CITY OF OREGON CITY HISTORIC REVIEW BOARD AGENDA

Virtual Meeting
Tuesday, January 25, 2022 at 7:00 PM

Staff Report

GLUA 21-00061 / HR-21-00024: Historic Review for New Construction at 724 Polk Street, site of the Clark S. Fuge residence, a historic landmark site.

STUDY SHEET
Garage / for,
Bell Residence
724 Polk St.
Oregon City, Oregon 97045

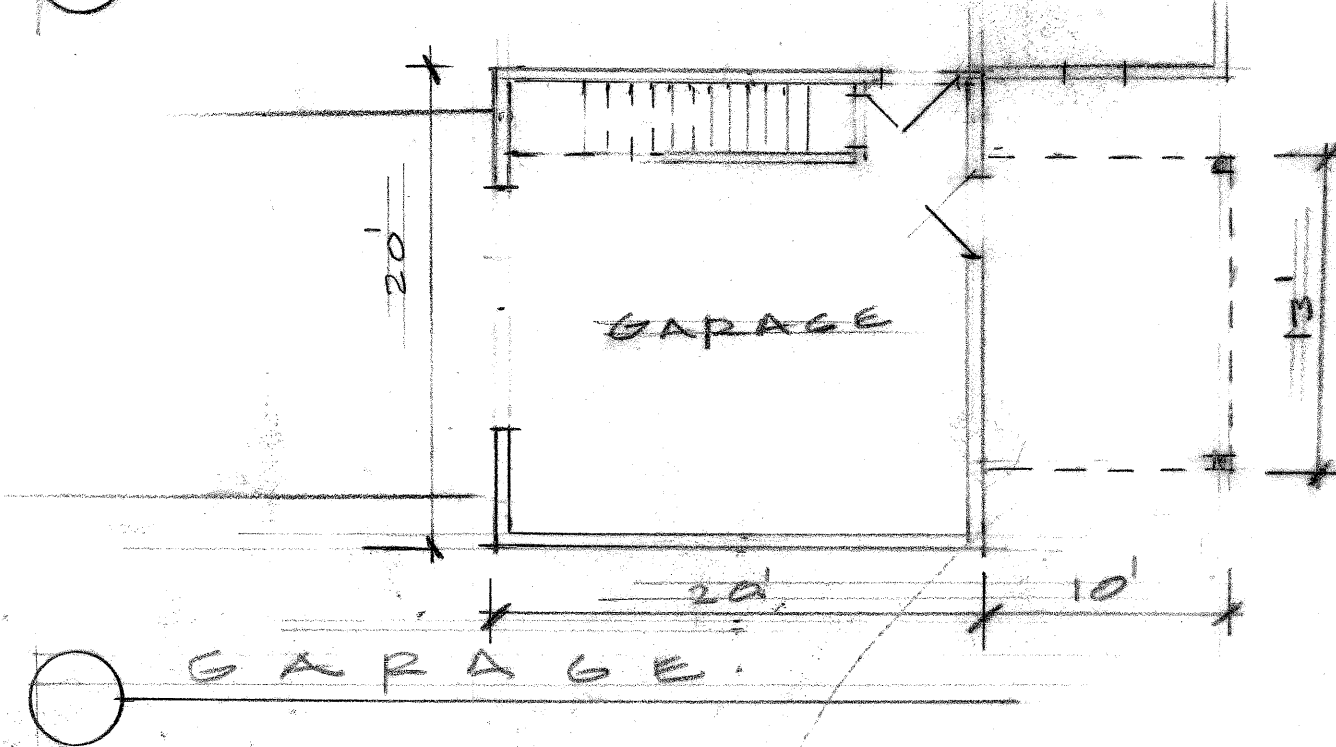
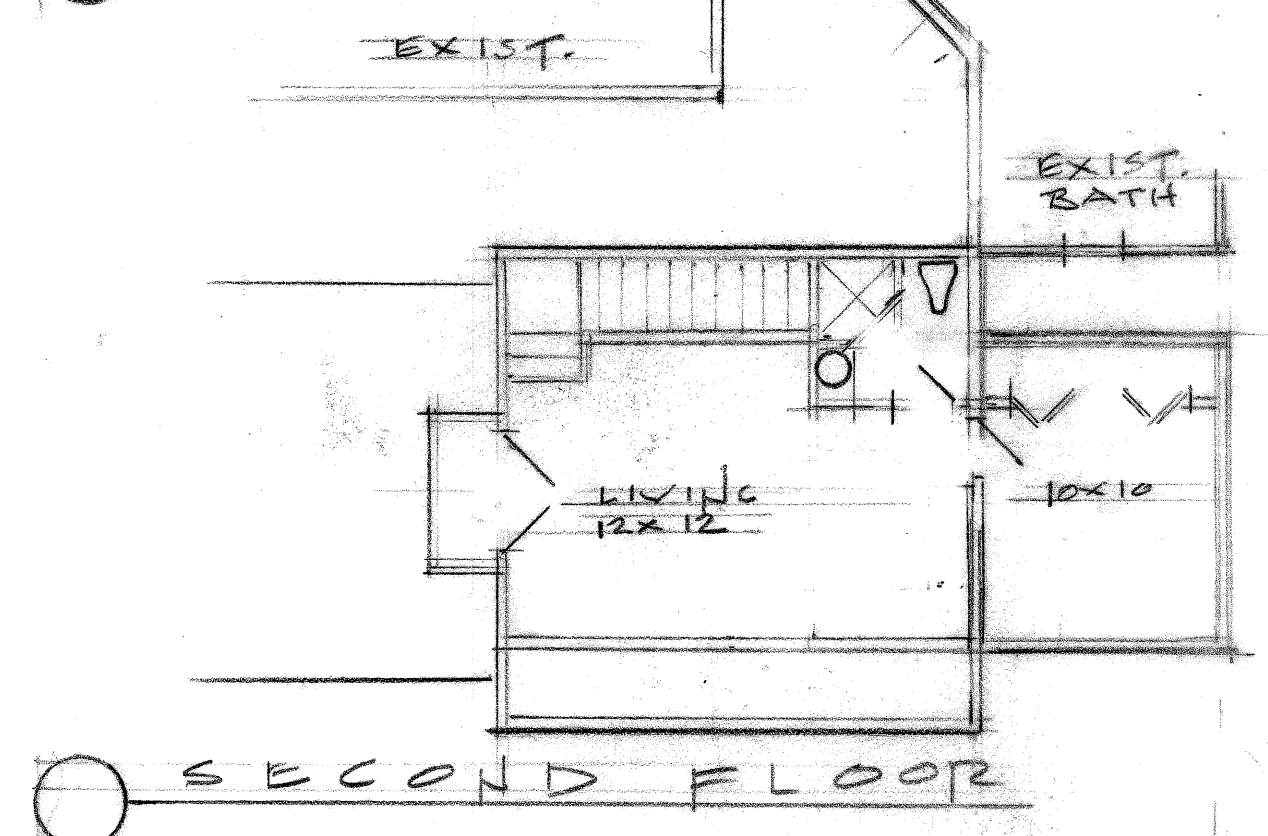
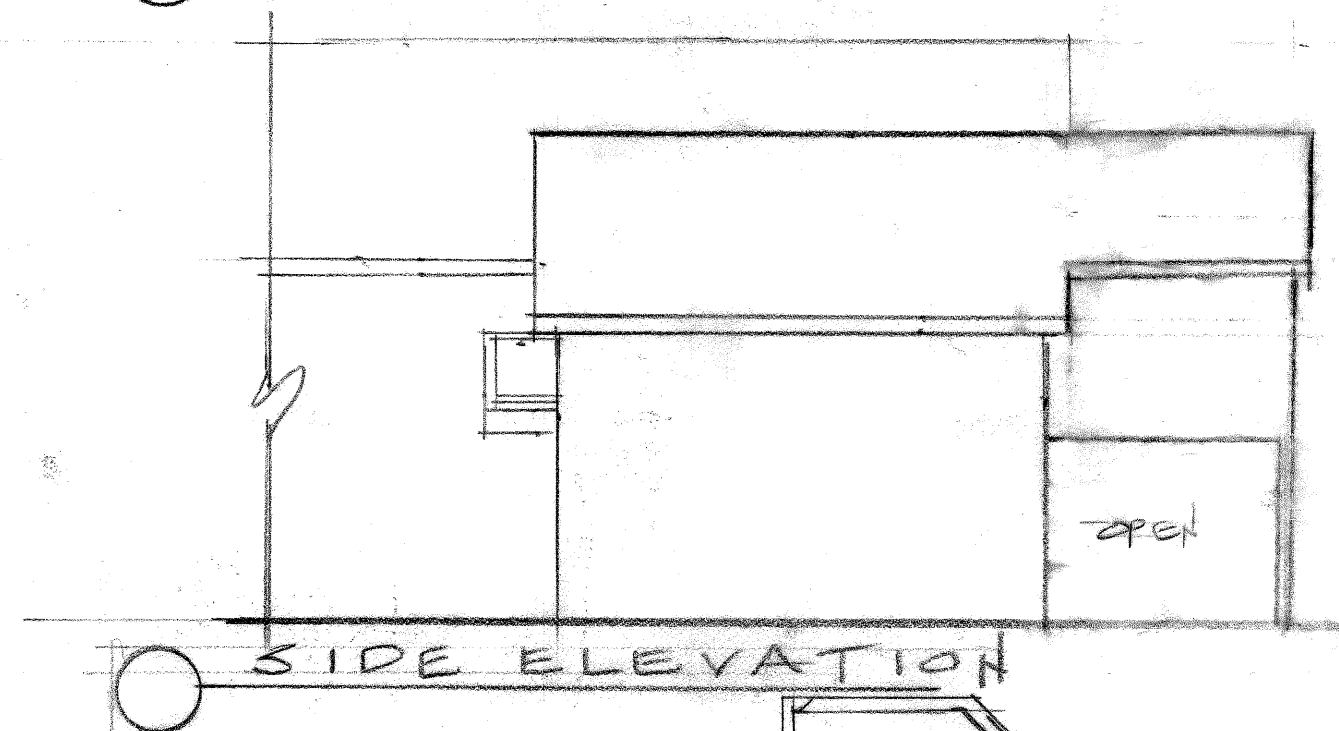
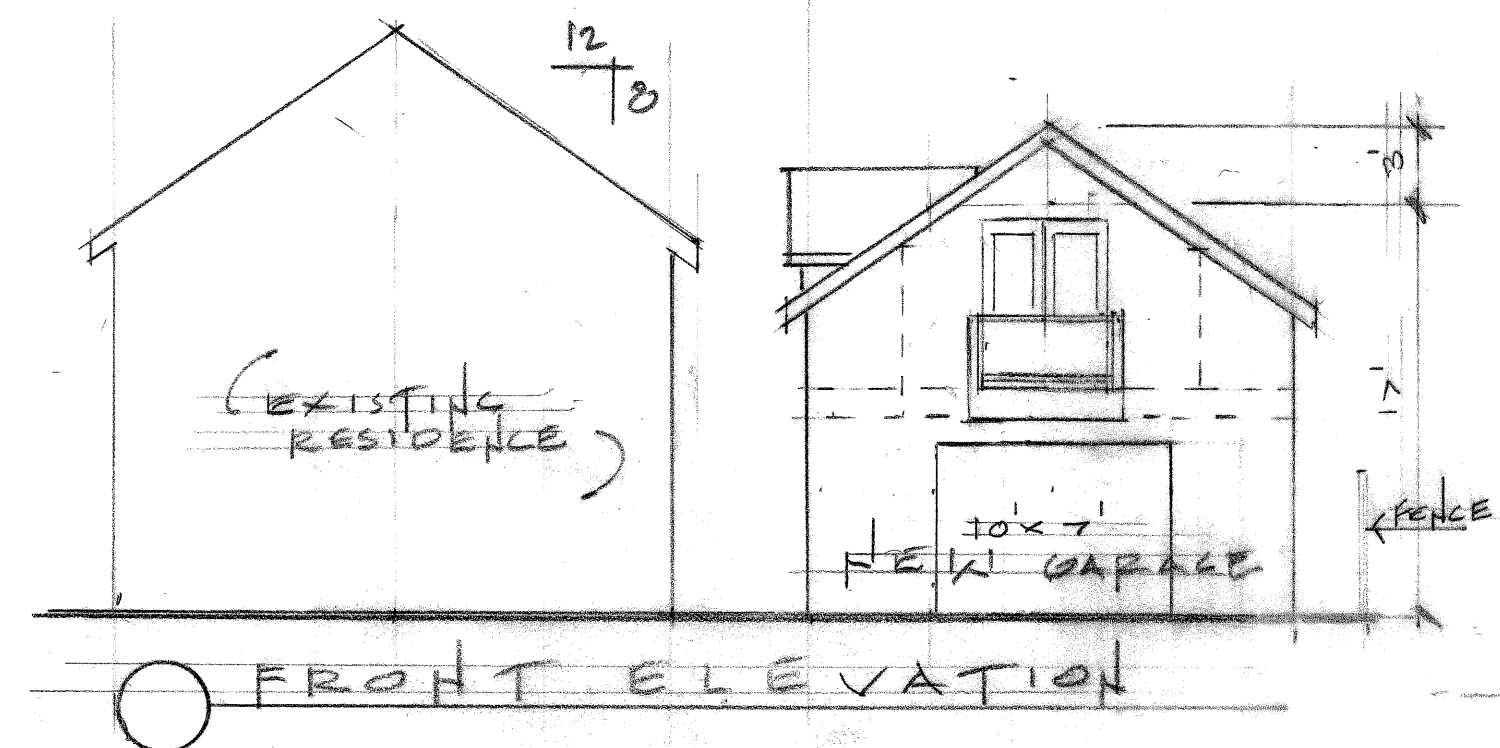
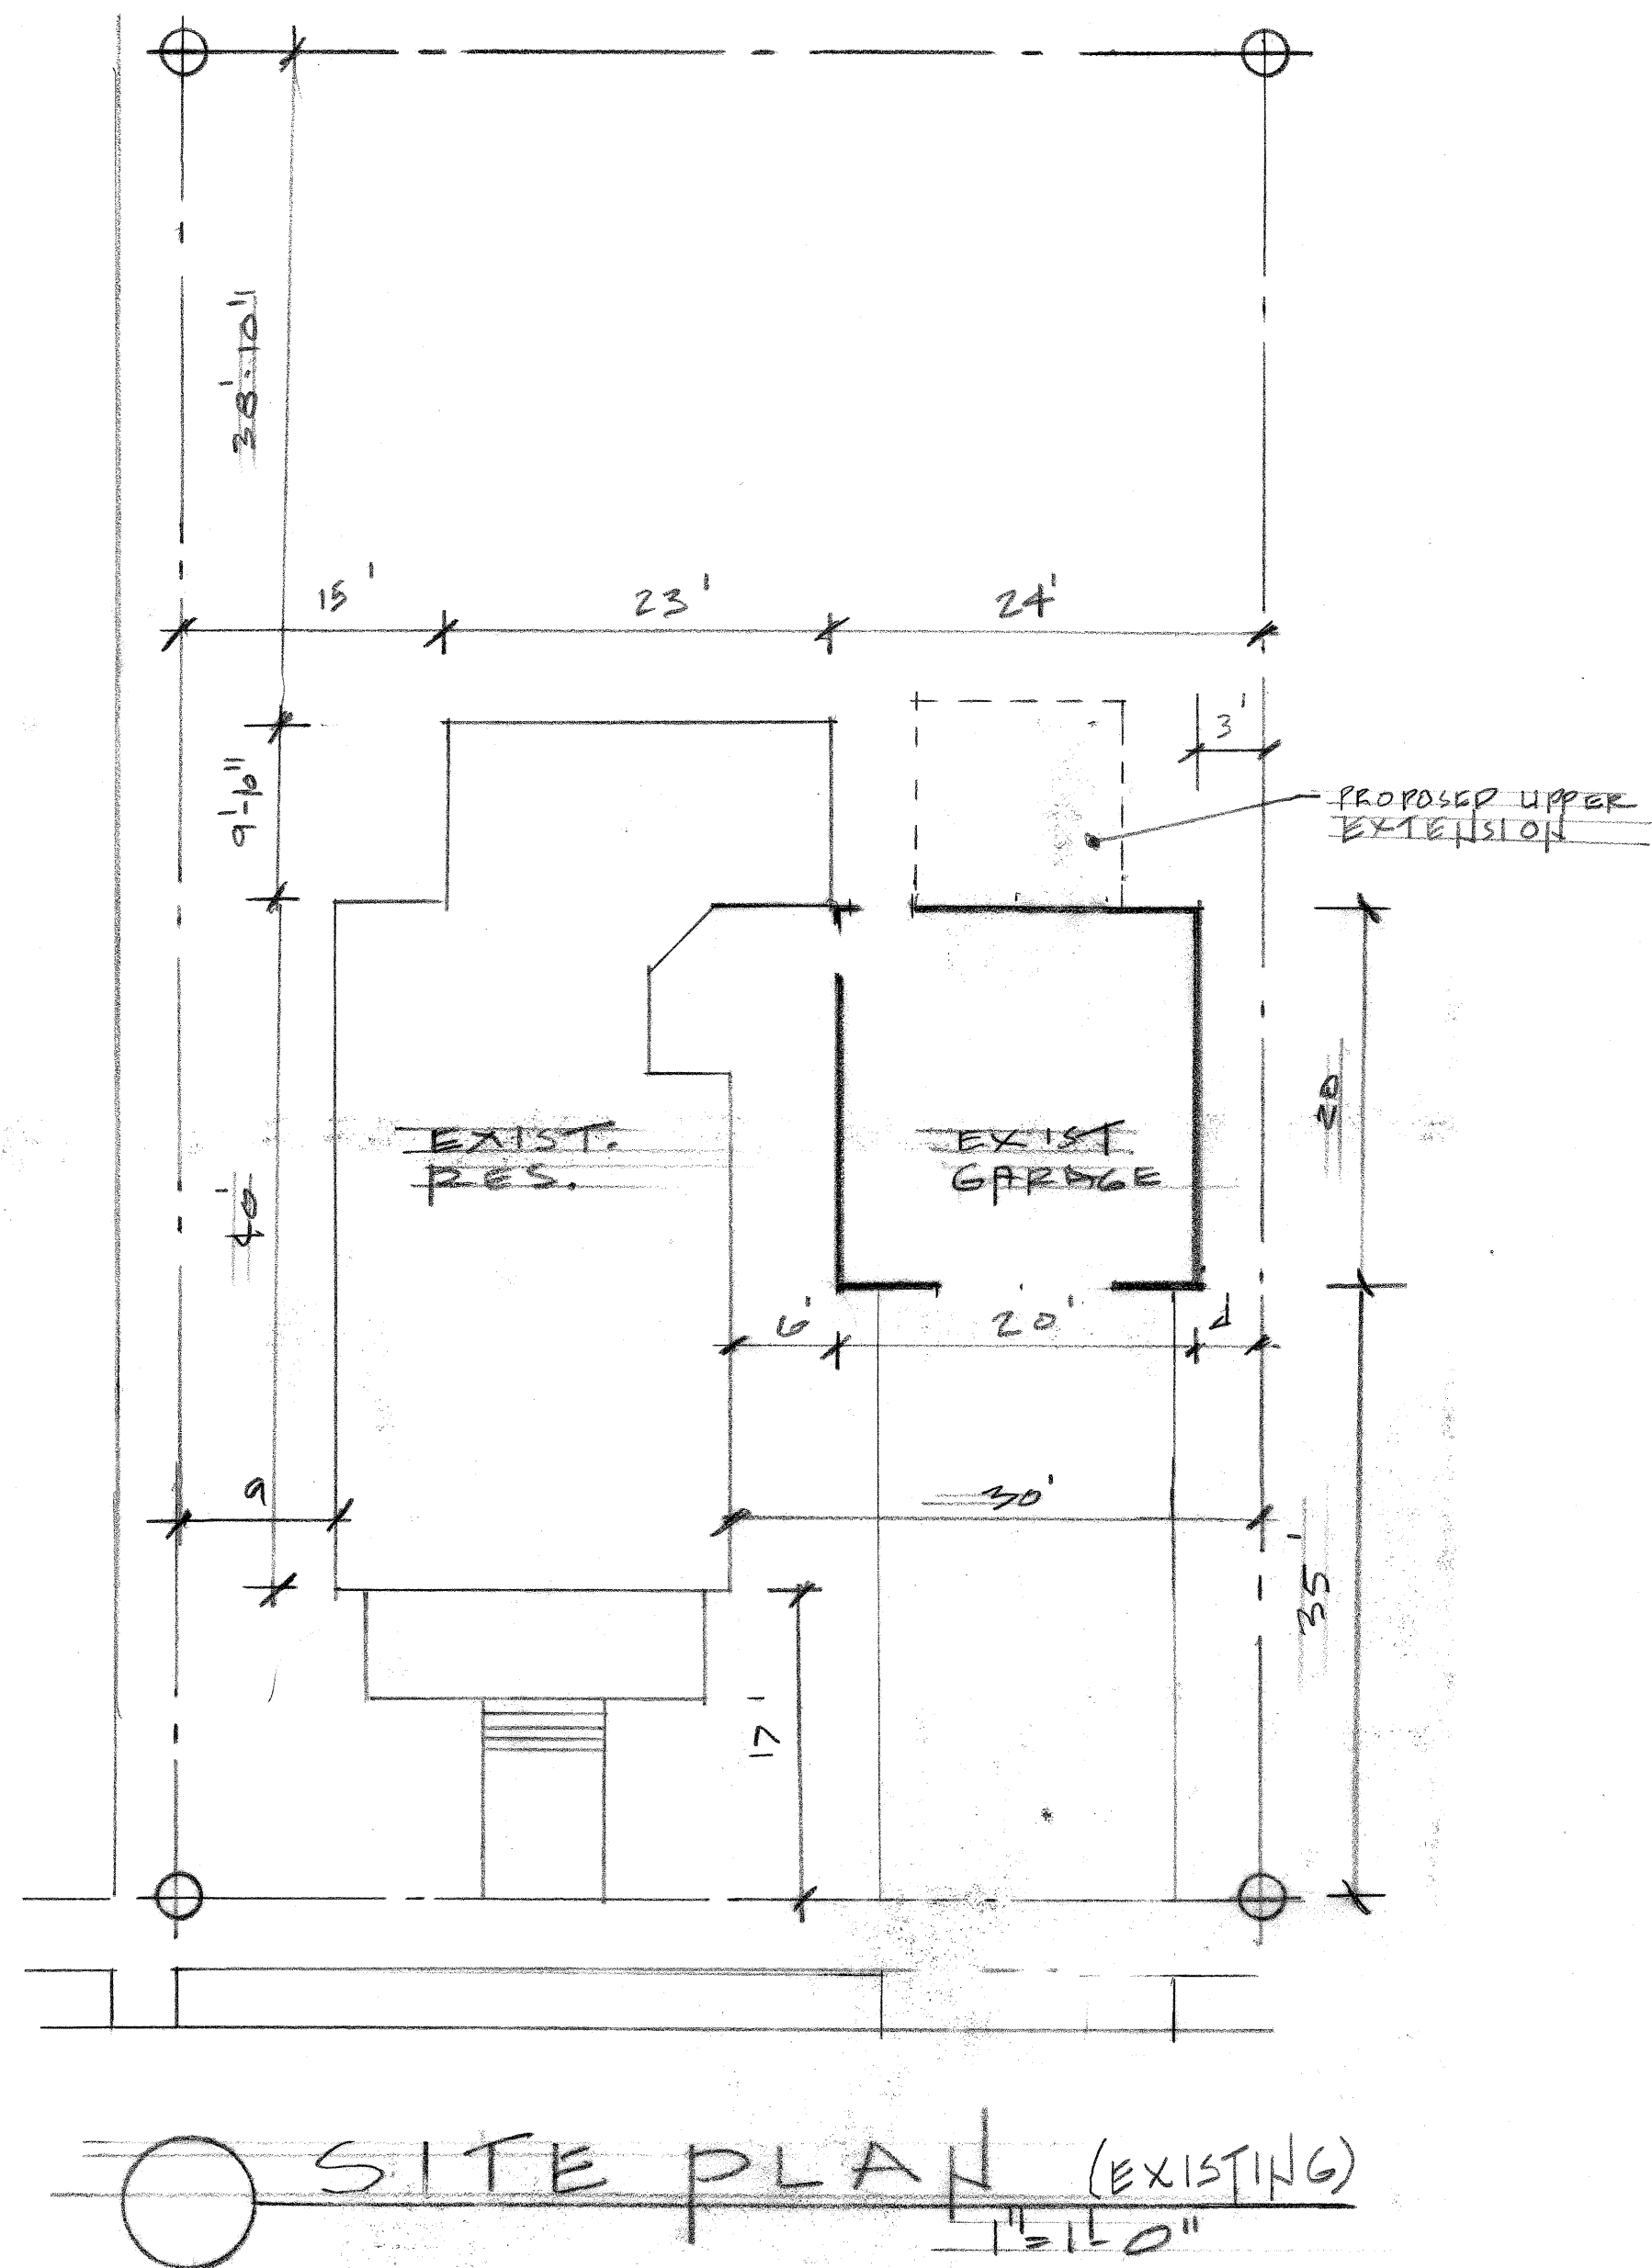
You have a note on the plans – “confirm window size” – do you have a proposed size for that window?

Your plans indicate a 2x2 skylight on the rear roof plane of the dormer if no window is included in the dormer – is that right?

Proposed window is 2” by 2’-6” . This could change in heigth when roof is attached.

Yes. But recent calculations show we will be using a window, so skylight will not be necessary.
